ALFRESCO

LX2 to Cart, Assembly Instructions

Supplemental for serial no.s 11-00000 forward

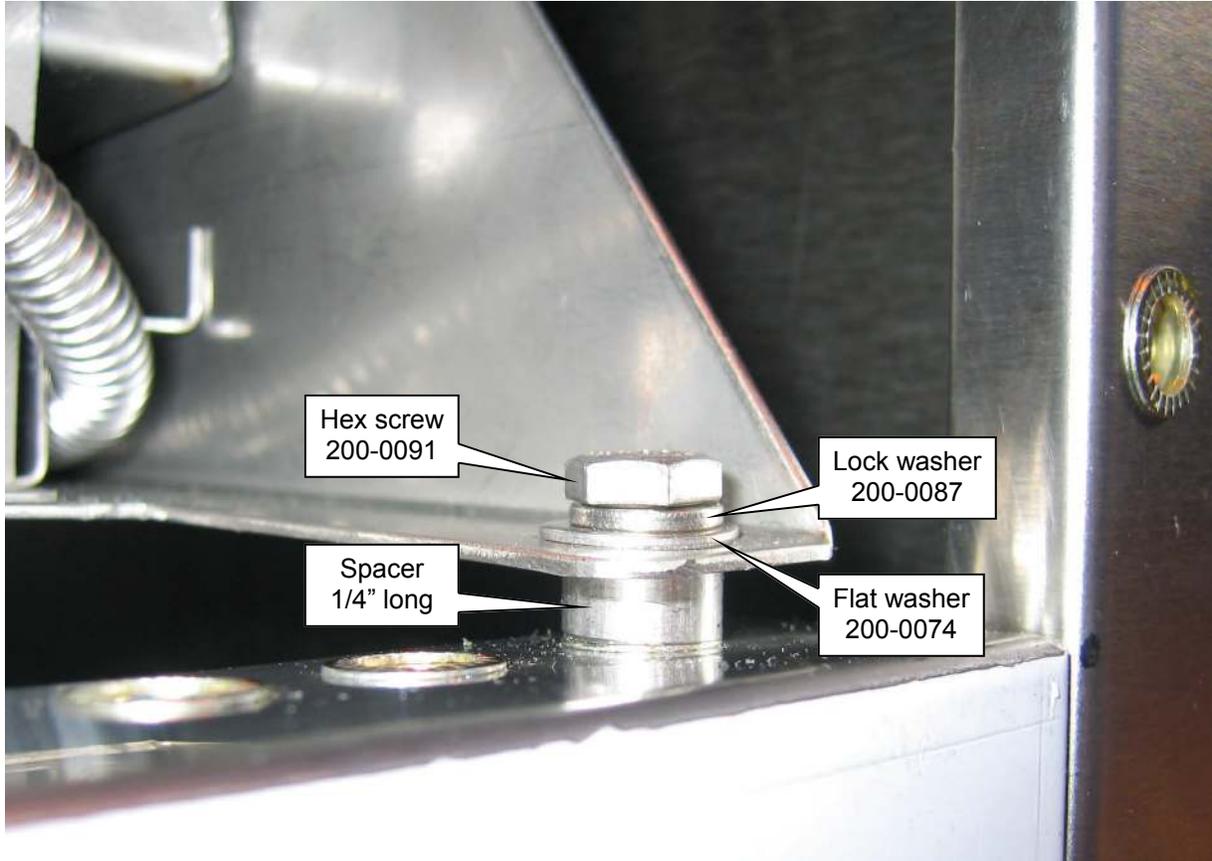
Due to a modification of the mounting brackets, mounting of the ALX2 barbeque to a cart has changed for barbecues with serial numbers 11-00000 forward. This change effects attachment of the barbeque to the cart as is shown in the following pages. Spacers are utilized in this process, these spacers are shown below. The 1/4" long spacers are used to attach the rear of the barbeque, while the 3/8" long spacers are used at the front.

1/2" x 1/4" x 1/4" long spacer

1/2" x 1/4" x 3/8" long spacer

Note: Failure to use these spacers will cause the barbeque to be inadequately secured to the cart. Over tightening of the mounting screws without the use of these spacers will damage either the barbeque, the cart or both.

THE FOLLOWING PROCEDURE SECURES THE REAR OF THE BARBEQUE TO THE CART.

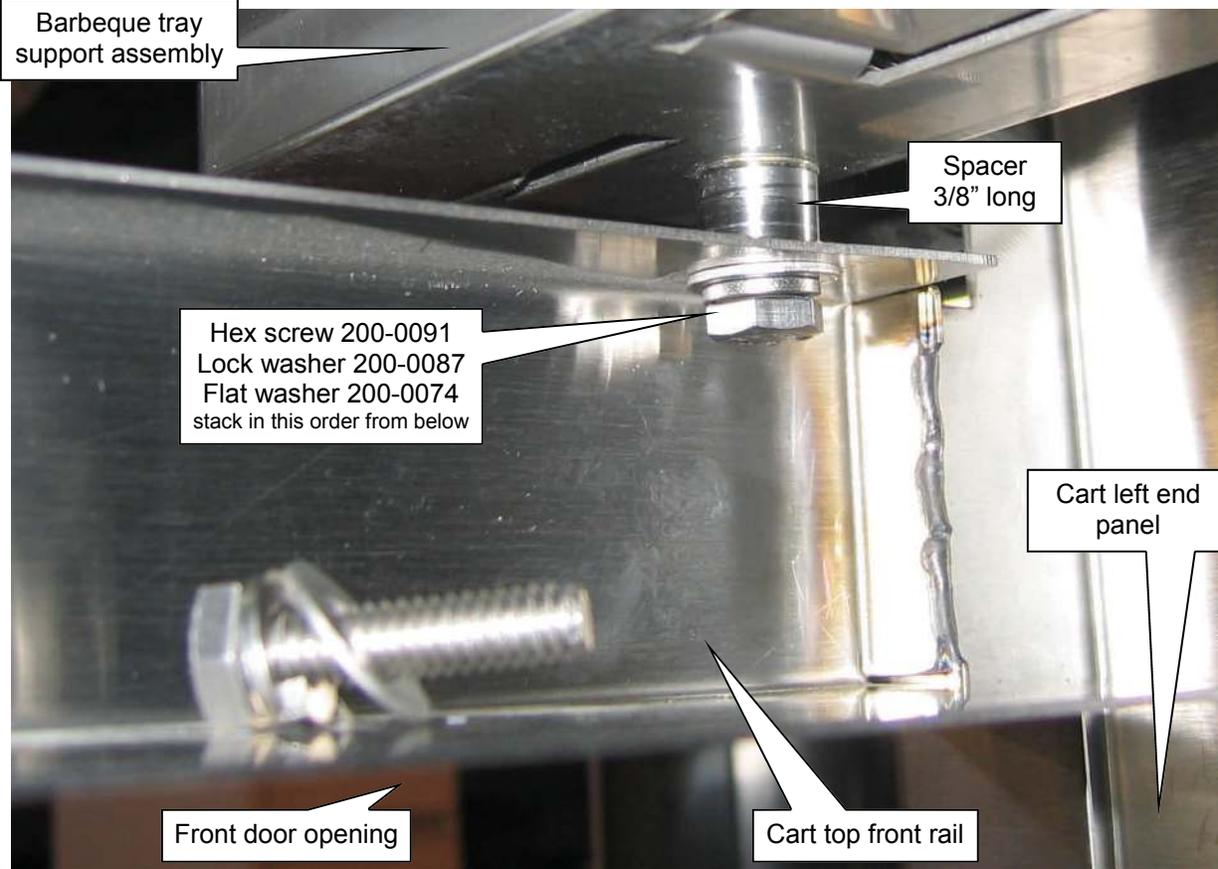
LEFT SIDE SHOWN - REPEAT FOR RIGHT SIDE.
